ADDENDUM NO. 3

RE: Architect's Project #: 2301 A1

Project: **Bandera County Visitor Center
Phase 2 – Historic Stabilization**

SHEET NO:
A-101

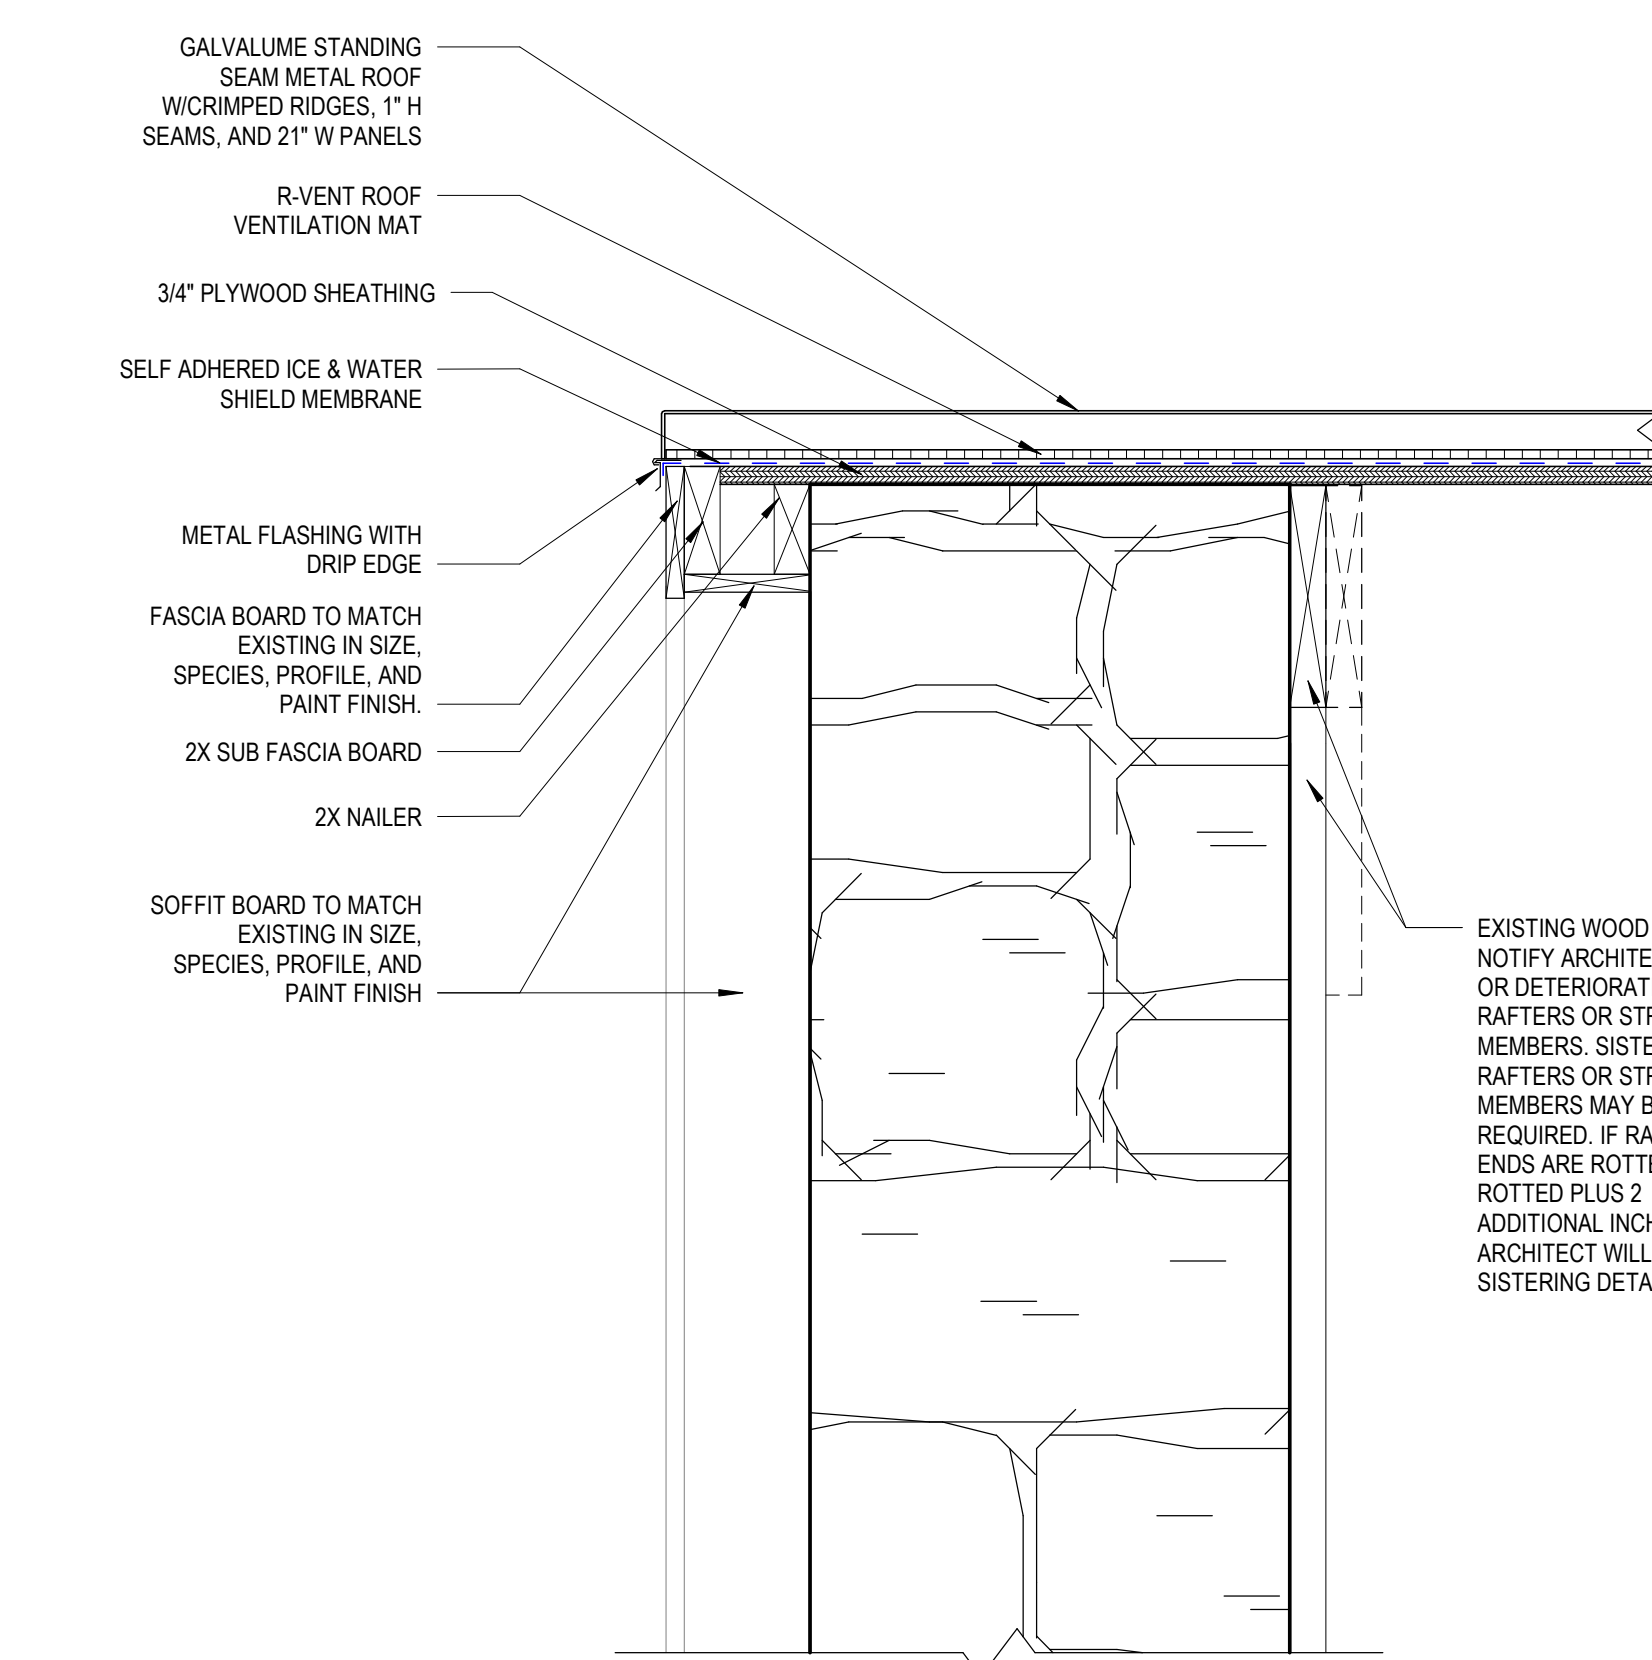
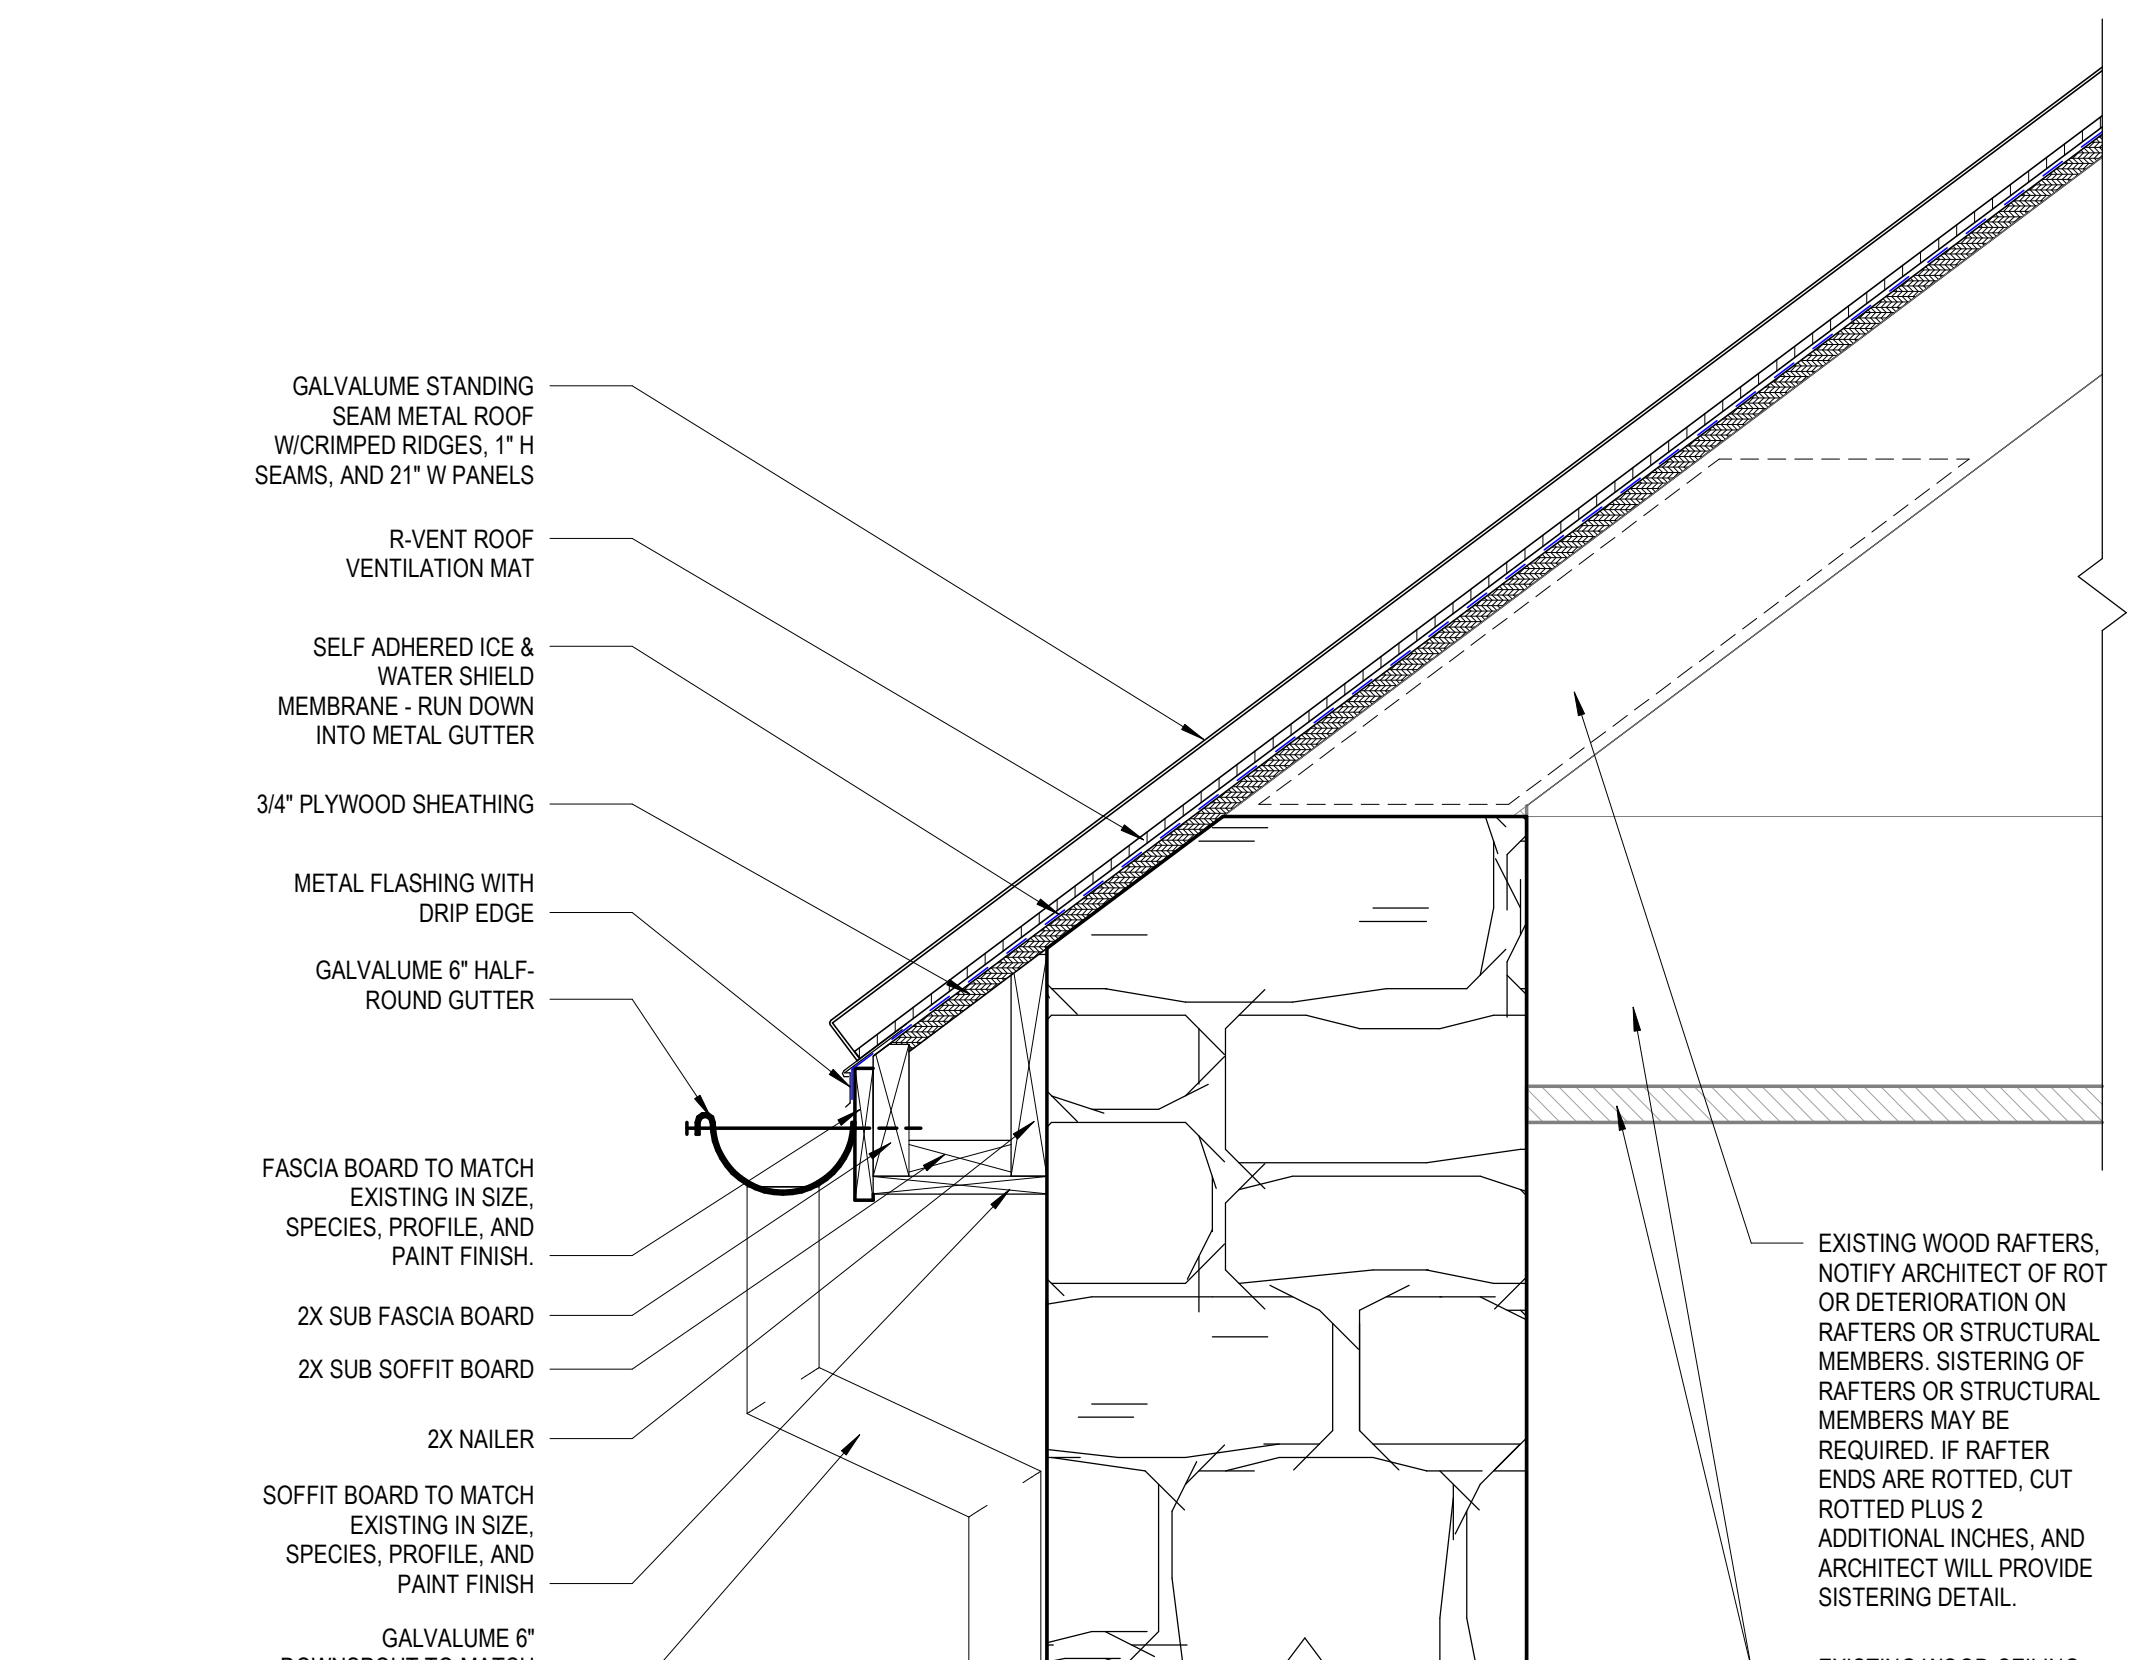
- c. Added solar powered roof vent to details 1 and 4
 - d. Clarified sistering note on detail 4
 - e. Clarified thru wall flashing note and added images to detail 5.

3. For the rafter replacement or sistering is there a spec or engineered requirement?
[Refer to Wood Framing Notes on Sheet A-101 for details.](#)
4. Detail 2/A-101 indicates to install ¾" plywood decking directly to the existing wood rafters. What grade of plywood is required?
[Refer to Wood Framing Notes on Sheet A-101 for details.](#)

5. Detail 2/A-101 indicates to install ¾" plywood decking directly to the existing wood rafters. It is assumed this decking must transfer diaphragm lateral loads to the rafters and resist uplift loads, however, no fasteners are specified. Will the client please provide the required fasteners to resist wind lateral and uplift loads?
[Refer to Wood Framing Notes on Sheet A-101 for details.](#)

6. The drawings do not include any details for fastening the existing rafters to the existing masonry walls to transfer wind lateral and uplift forces. Please confirm the contractor is not required to install any new fasteners or connections at the rafter-to-wall intersections.
[Refer to Wood Framing Notes and Nailing Schedule on Sheet A-101 for details.](#)

9. Please advise if R-Vent Roof Ventilation Mat by Advanced Building Products would be acceptable.
[No](#)
10. Can you please advise if the vent membrane may be removed from the scope due to the crimple ridge – or if there is a different method intended to vent the roof. The crimped ridge will not allow for the venting membrane to function as intended.
[The vent membrane must remain. Please refer to detail 4/A-101.](#)

- WF-1 LUMBER SHALL CONSIST OF DOUGLAS FIR, KILN DRIED W/ A MOISTURE CONTENT OF 19% MAXIMUM AT THE TIME OF INSTALLATION, UNLESS NOTED OTHERWISE.
- WF-2 ROOF SHEATHING SHALL BE 5/8" EXTERIOR PLYWOOD OR OSB OVER WOOD JOISTS. PROVIDE ADEQUATE BLOCKING, TONGUE AND GROOVE EDGES OR PLYCLIPS (2 FOR 48" SPAN), USE 10d NAILS (1/2" PENETRATION) AT 6" O.C. AT END JOINTS.

CONNECTION	NAILING	LOCATION
1. CEILING JOIST TO PLATE	(3) 8d COMMON	TOENAIL
2. CEILING JOIST, LAPS OVER PARTITIONS	(3) 16d COMMON	FACENAIL
3. CEILING JOIST, TO PARALLEL RAFTERS	(3) 16d COMMON	FACENAIL
4. RAFTER TO PLATE	(3) 8d COMMON	TOENAIL
5. COLLAR TIE TO RAFTER	(3) 10d COMMON	FACENAIL
6. ROOF RAFTER TO 2x RIDGE BEAM	(2) 16d COMMON	TOENAIL
	(2) 16d COMMON	FACENAIL

11. Re: 5/A-101: Please provide more detail at top of chimney. If this chimney is to be functional, there is a concern over wood being exposed to the smoke/heat as shown. Framing is not clear as to provide for ventilation. Flashing details are also not clear (re: extent of waterproofing, through wall flashing).

- Chimney will not be functional. Refer to detail 5/A-101 for clarification on flashing detail.
12. Is the through wall flashing at chimney, indicated by blue dashed lines, existing? If required to be new, is the through wall portion to be at roof side only? If required, is there a specified level or distance (above roof, below cap or stone course) that through wall is to be achieved? Is material to match galvalume metal specified at roof flashing?
The blue dashed line indicates new through wall flashing that is to be applied only to the roof side of the wall, refer to detail 5/A-101 for clarification on how to install. Flashing to match galvalume metal specified at roof.
